MOTORCYCLE INDUSTRY COUNCIL

FACTORY DIRECTED MODIFICATION REPAIR AS DIRECTED

OIL LIGHT STAYS ON

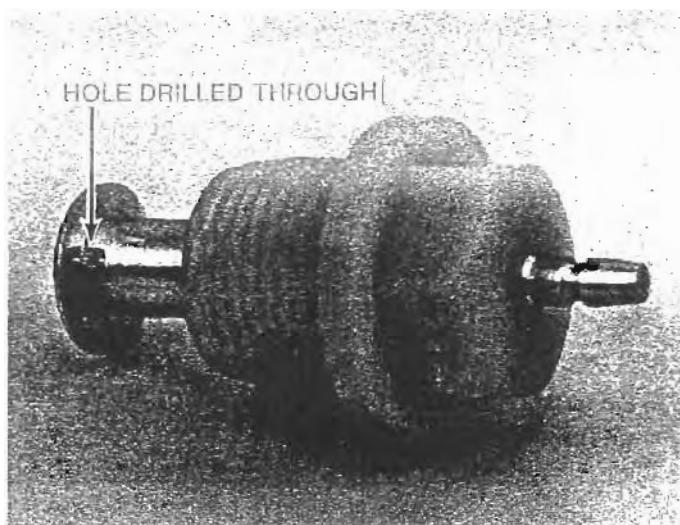
1. Remove the oil pressure indicator switch. Inspect the air-bleed hole in the switch plate.

2. If the hole is partially obstructed, redrill the hole 1.5mm in diameter (1/16 in. or No. 53 drill), as shown. **NOTE:** Do not exceed this diameter, or the warning light will not go out. Install the switch.

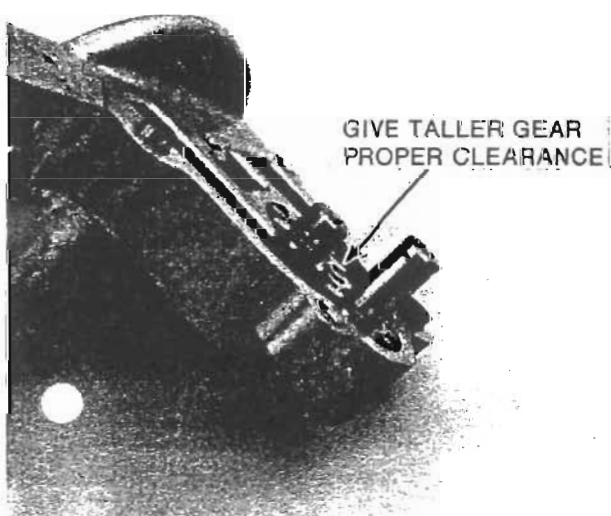
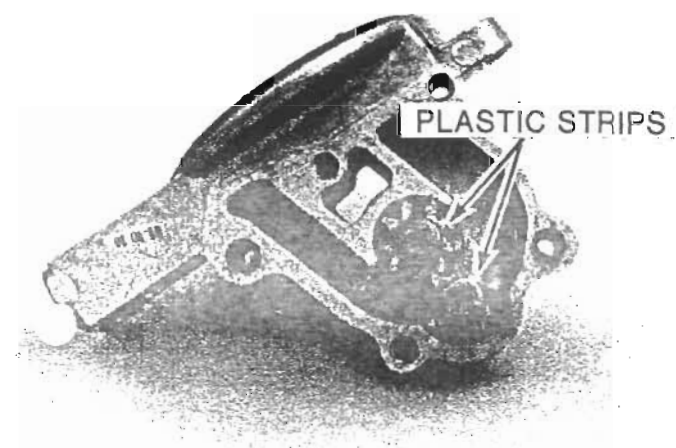
3. Remove the oil pan and the oil pump.
4. Measure the gear-to-cover clearance with Plastigage, as shown. Be sure to lay the plastic strip across the gear tooth with plenty of room for expansion. Consult the Clearance Table to choose the correct gasket and repair procedure.

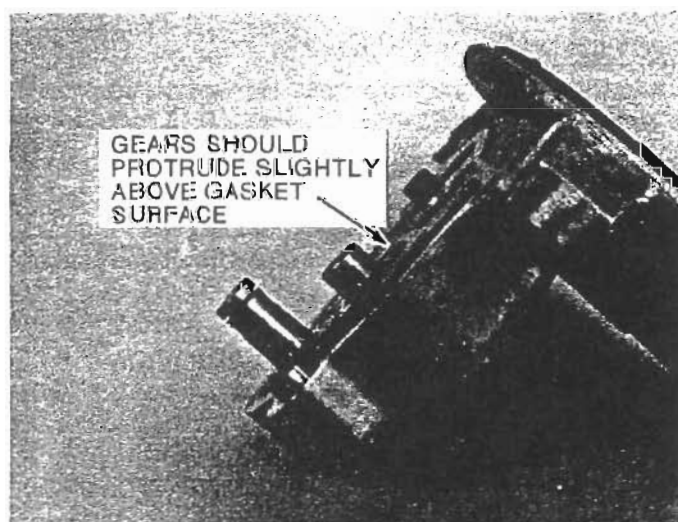
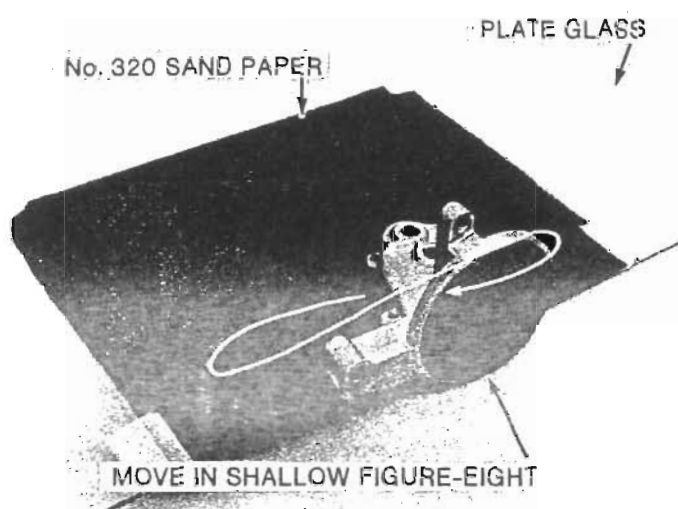
5. Clearance over 0.10mm cannot be corrected with a gasket alone. In this case the pump body must be lapped, as shown. Be careful not to remove too much material. To check, go back to step 4.

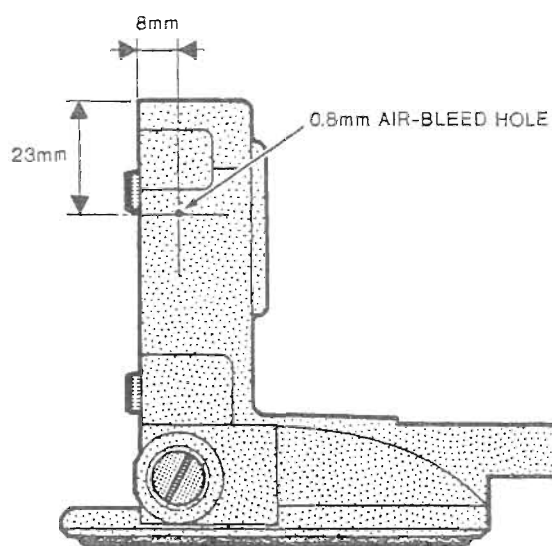
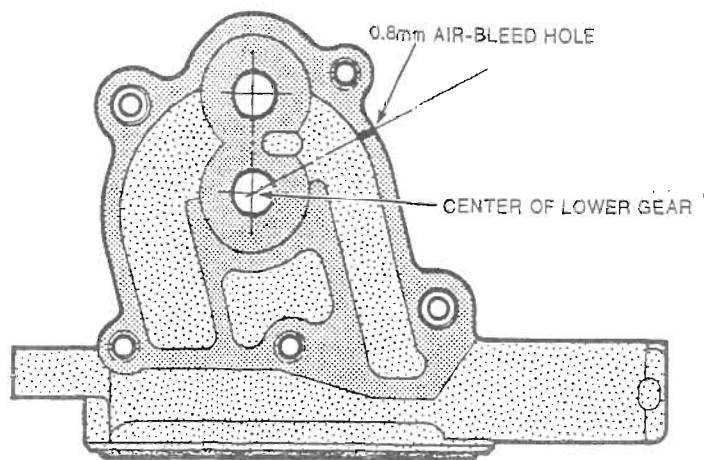
6. To drill the pump air-bleed hole, first remove the gears and stuff rags into the oil passage holes. In the position and direction shown, drill a hole 0.8mm in diameter (1/32 in. or No. 68 drill). This hole should be spaced 8.0mm (0.32 in.) from the gasket surface.
